POST-OCCUPANCY EVALUATION REPORT

TE KARAKA AREA SCHOOL

GISBORNE DISTRICT | JUNE 2015

Slippery tiles to entrance of both the administration and gym buildings

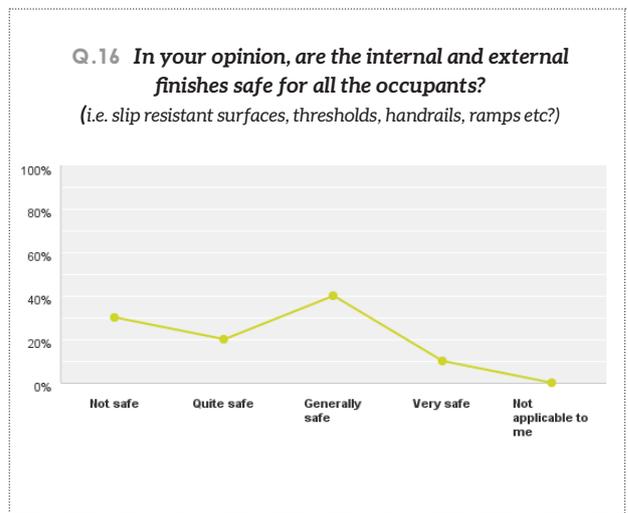
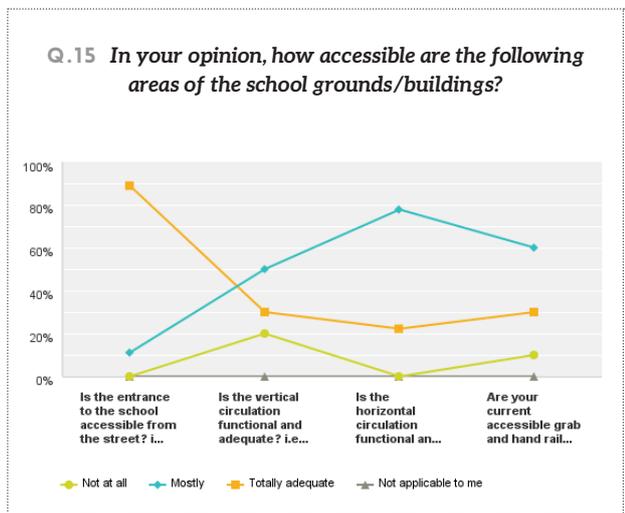
Of those surveyed, 55% stated that some of the internal and external finishes were ‘not safe’ or ‘quite safe’ for its occupants. The main issue was the external tiles to the entrance of the administration and gym buildings being very slippery when damp (see graph Q16 below).

1. Exterior landscaping materials need to have sufficient slip resistance to ensure safety. The tiles in front of the gym and administration appear unfit for purpose in this regard.

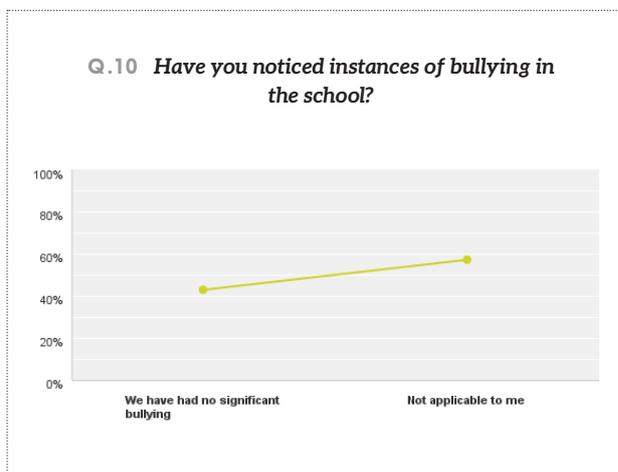
The design team has not adopted any sustainable rating scheme for the buildings or infrastructure (Greenstar or similar). During the interviews the school’s leadership team stated that the energy consumption of its new buildings was higher than expected. The evaluation team quantified the school’s energy usage over a 12-month period and noted considerable fluctuations in the first year of operation. It is expected that this may stabilise over a few annual cycles following the first year of operation before a pattern can be determined and conclusions drawn. During the interviews it was noted that the first time the heating system was turned on it overloaded the electrical system.

To resolve this issue the heating system is now limited to 50% of the specified output. It is recommended that further diagnostic investigation is carried out to define this situation in more detail.

Bracing Plan Drawing

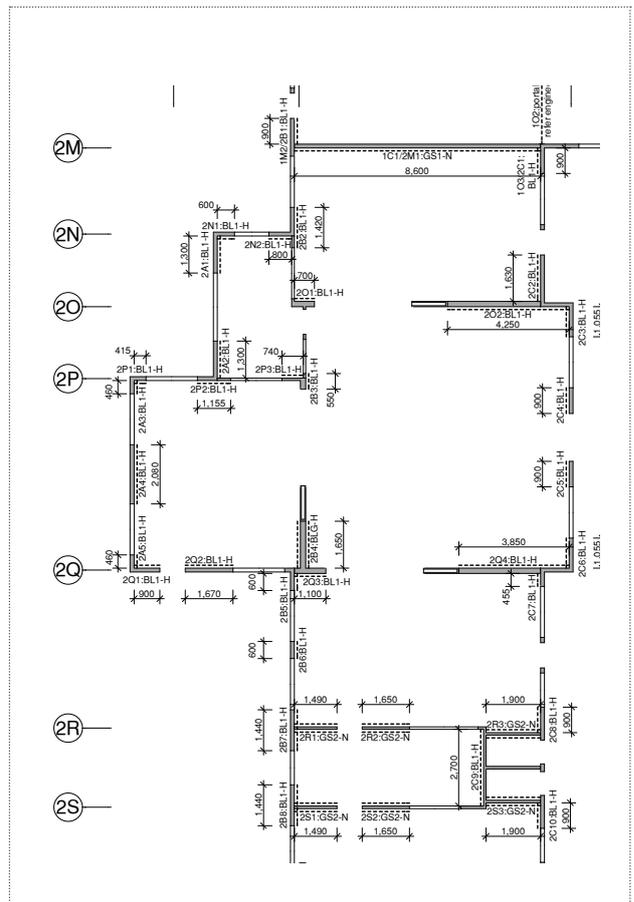
Residential methods of construction have been applied throughout. A large number of the internal walls are used for bracing, which could prove costly if alterations to the space were needed in the future. A more commercial approach to the structural design would have reduced the amount of internal load bearing and bracing walls. Although this approach may have initially cost more, it would have provided a more flexible building (see bracing plan drawing right).

Gap between canopy and building

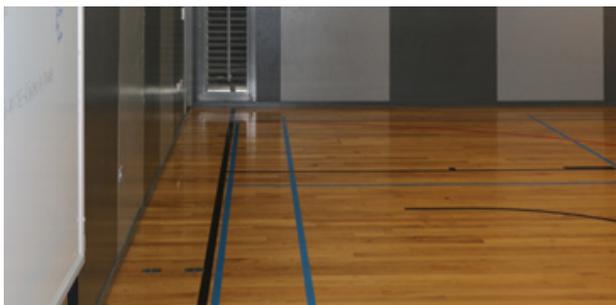
1. As the external canopies are not connected to the building “when it rains everybody gets wet when entering classrooms”
2. Staff suggested a security alarm keypad in the learning centres by the staff car park would be beneficial
3. Staff would have liked more space around the gym court for spectators

4. The external canopies should adjoin the buildings to offer full weather protection.
5. In this instance the Principal was part of the design team. This benefitted the school positively as the school's educational vision could be aligned with the facilities at the outset. Further strategies should be explored to assist the pedagogy development of new schools within the design phase.
